BOUNDARY & TOPOGRAPHIC SURVEY
DOMINICAN PARCEL A.P.N (015-163-03)
MARIN COUNTY
CITY OF SAN RAFAEL

TENTATIVE MAP, DOMINICAN VALLEY SUBDIVISION
DOMINICAN PARCEL A.P.N (015-163-03)
MARIN COUNTY, CALIFORNIA

PRELIMINARY GRADING PLAN
 DOMINICAN PARCEL A.P.N. (015-163-03)
 MARIN COUNTY, CALIFORNIA

<p>PRELIMINARY DRAINAGE PLAN</p> <p>DOMINICAN PARCEL A.P.N. (015-163-03)</p> <p>CITY OF SAN RAFAEL</p>	<p>OBERKAMPER & ASSOCIATES</p> <p>CIVIL ENGINEERS INC.</p> <p>7200 REDWOOD BLVD SUITE 305 SOVATO, CA 94945 PHONE: (415) 897-2800 WWW.OBERKAMPER.COM</p>
<p>Scale: 1" = 60'</p> <p>Drawn by: BM</p> <p>Field Crew: AS</p> <p>Checked by: LEO</p> <p>Date: 12/1/2023</p>	<p>SHEET</p> <p style="font-size: 2em; font-weight: bold;">C5</p> <p>5 OF 6</p> <p>22-192</p>

Scale: 1" = 60'
 Drawn by: BM
 Field Crew: AS
 Checked by: LEQ
 Date: 12/17/2023
 SHEET
C4
 4 OF 6
 22-192

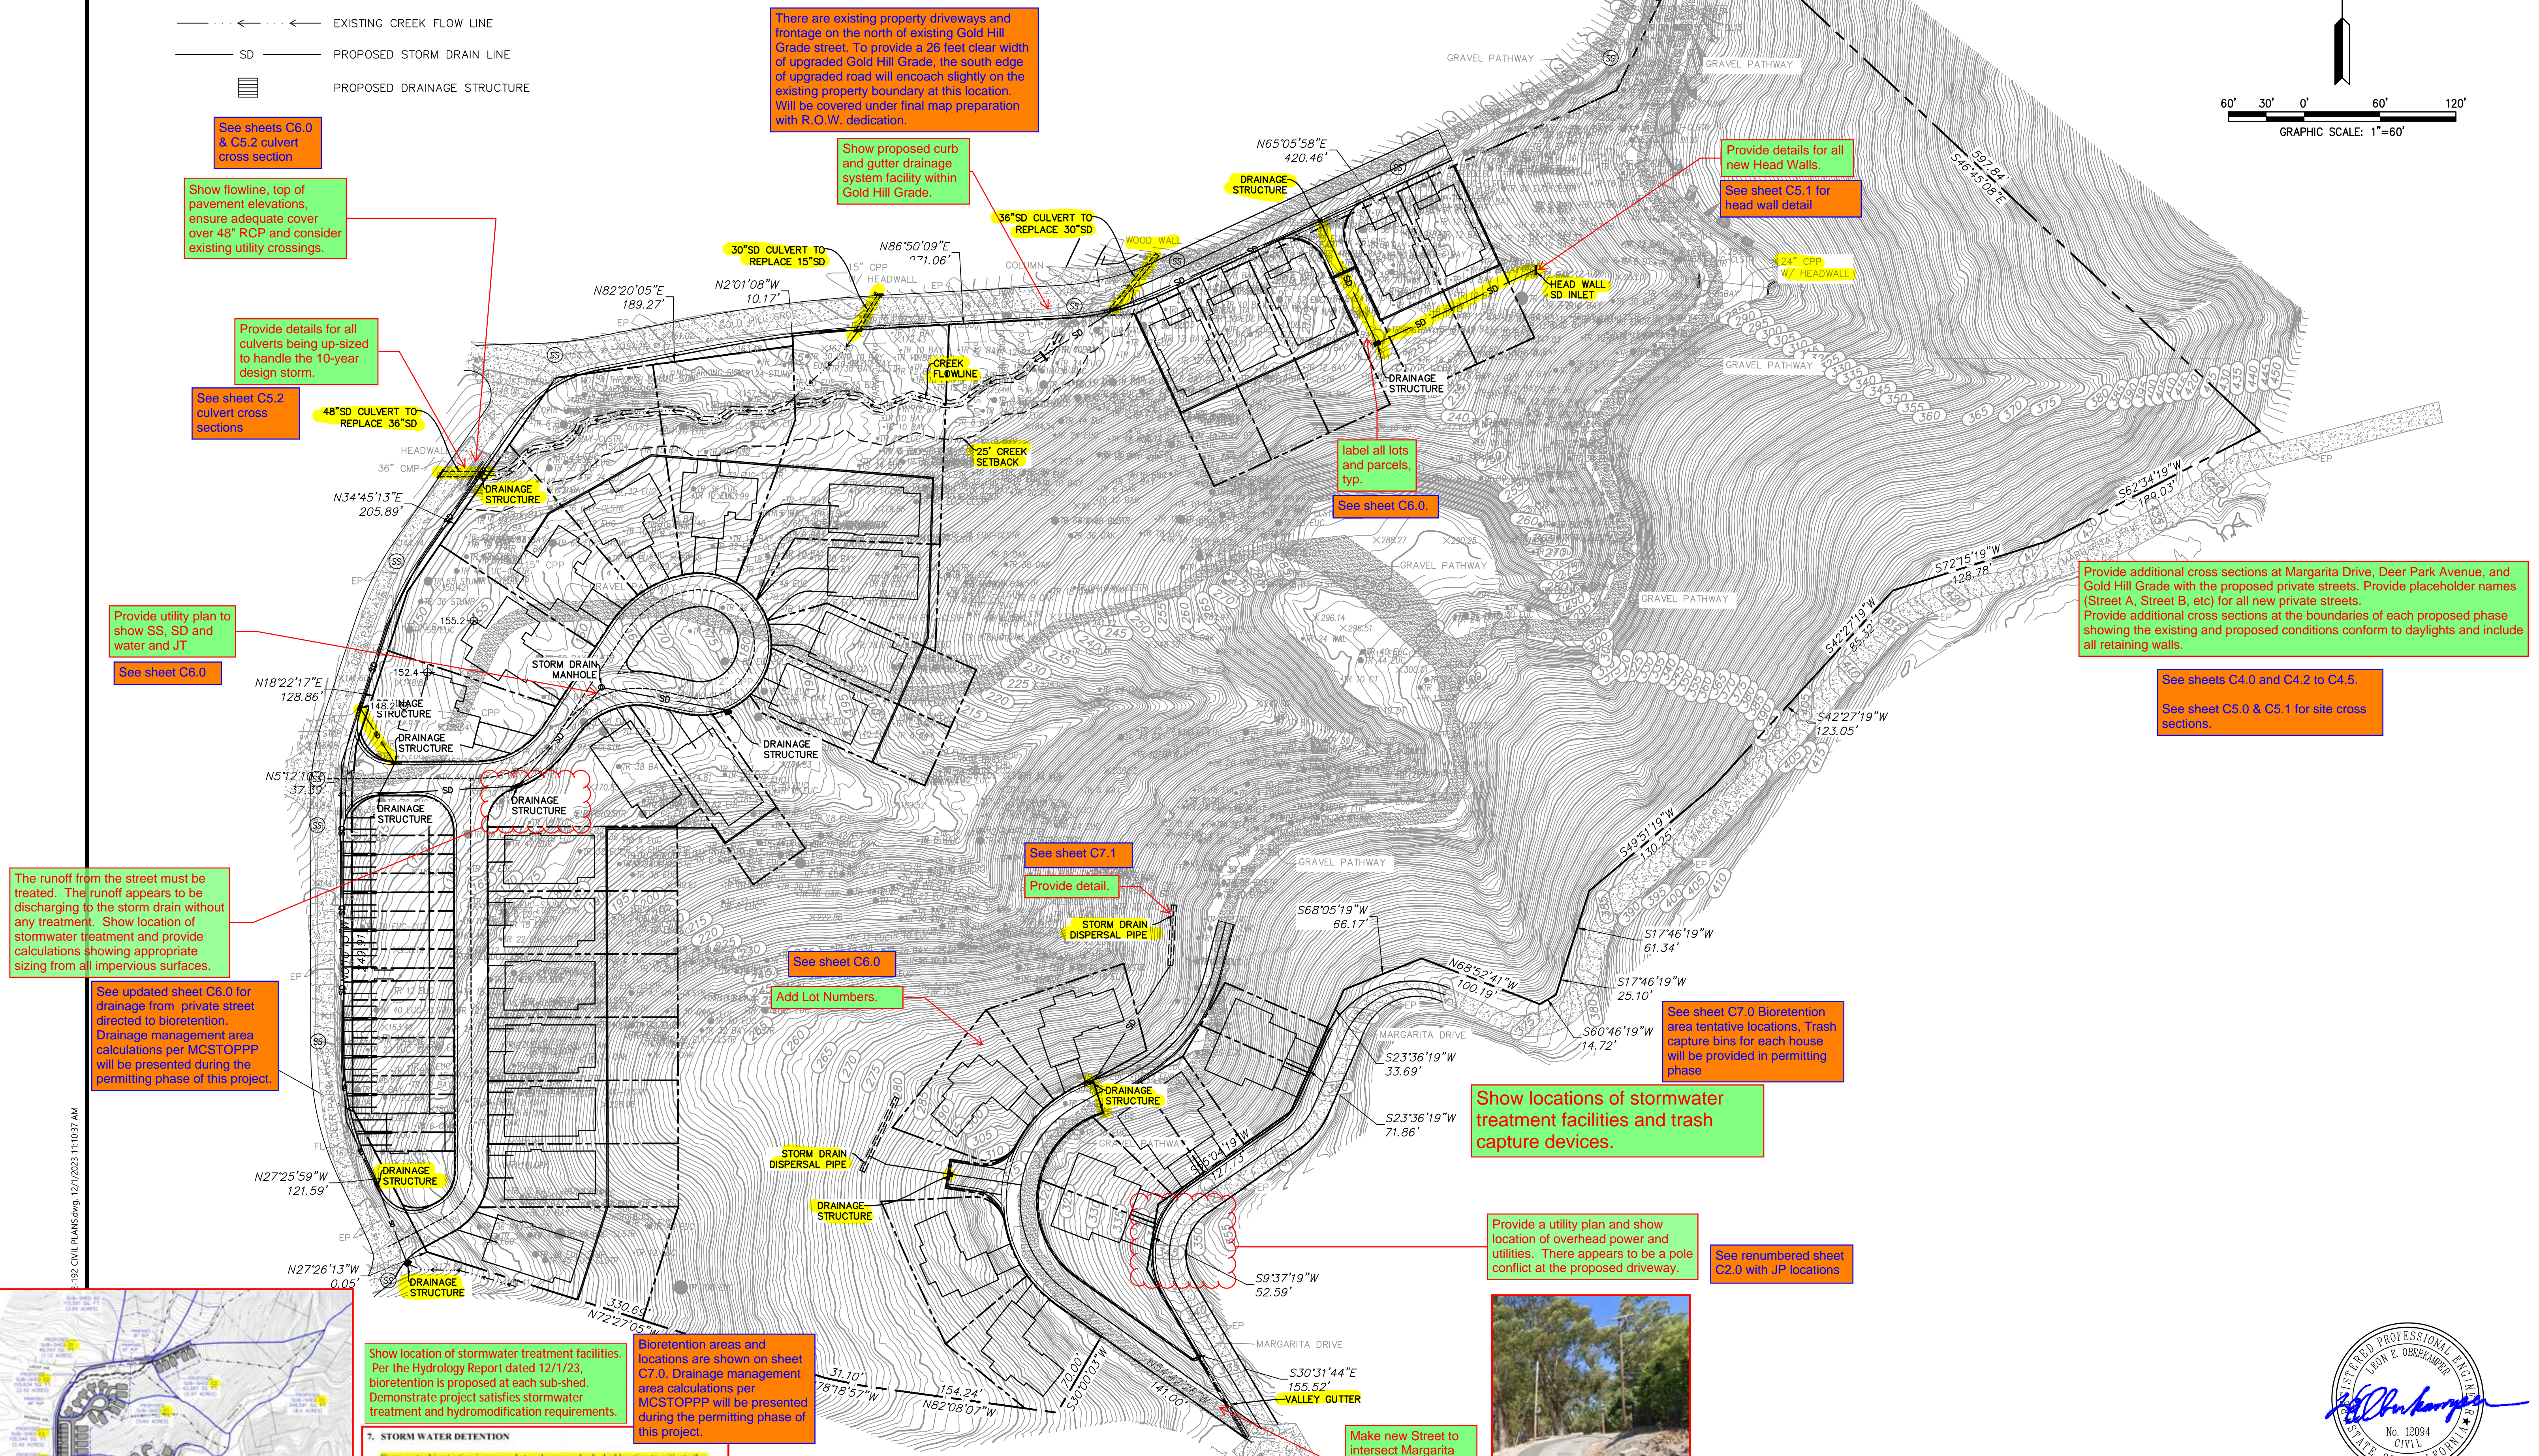
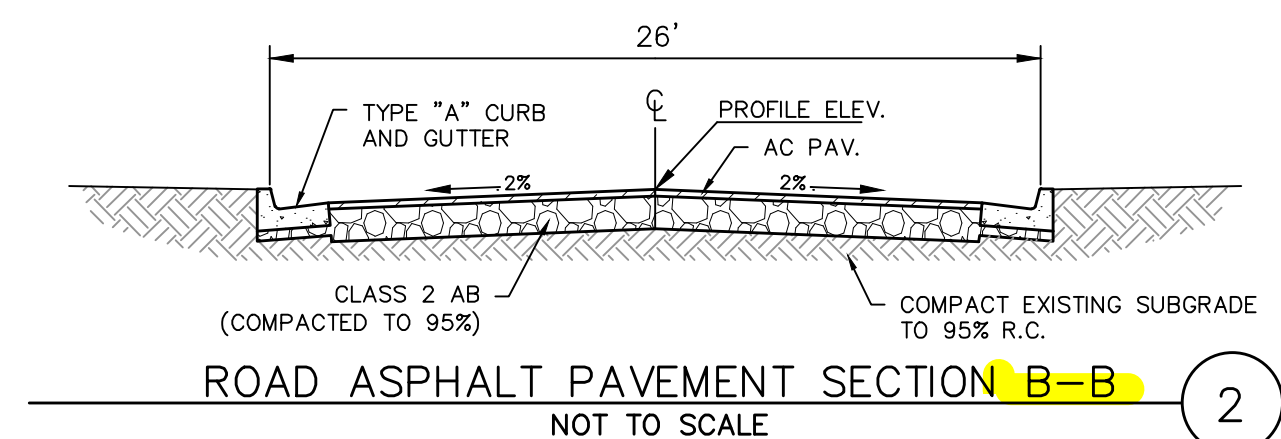
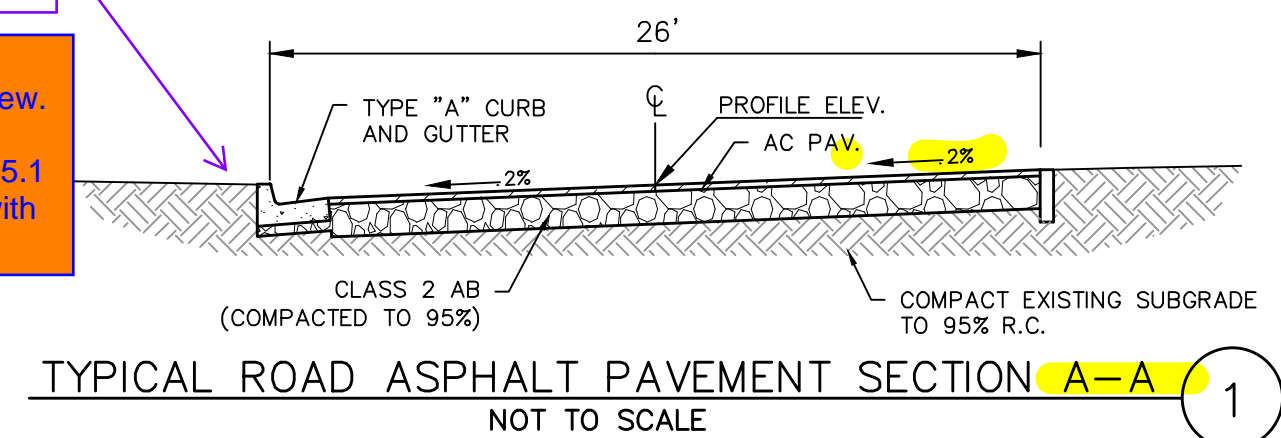
Add Pad Elevation.
See sheet C4.2 to C4.5

Added, see sheet C4.0 to C4.5
Add Lot numbers (typ.).

Added, see sheet C4.2 to C4.5
Add Pad Elevation.

Provide details for all culverts being up-sized to handle the 10-year design storm, typ.

Add Pad Elevations, typ.

Provide section for Deer Park Ave and Gold Hill Grade

Please provide cross sections through the multifamily homes and Deer Park Avenue to clarify conform between existing infrastructure and proposed improvements.

Show cross slope and direction of flow

Provide top of wall (TW) and bottom of wall (BW) elevations, typ.
See sheet C4.0 to C4.5

15.02.030 g - Provide street name and grades of all roads

Include ROW limits on typical sections, typ.

Provide additional cross sections at Margarita Drive, Deer Park Avenue, and Gold Hill Grade with the proposed private streets. Provide names for all new private streets. Provide additional cross sections at the boundaries of each proposed phase showing the existing and proposed conditions conform to daylight and include all retaining walls.

See sheet C5.3

Added, See sheet C4.2 to C4.5

See sheets C4.0 and C4.2 to C4.5.

See sheet C5.0 & C5.1 for site cross sections.

See sheets C4.0 and C4.2 to C4.5.

See sheet C5.0 & C5.1 for site cross sections.

See sheet C4.0 to C4.5

See sheet C4.0 for ROW limit in plan view.

See sheet C5.0 & C5.1 for street sections with ROW lines

See sheets C4.0 and C4.2 to C4.5.

See sheet C5.0 & C5.1 for site cross sections.
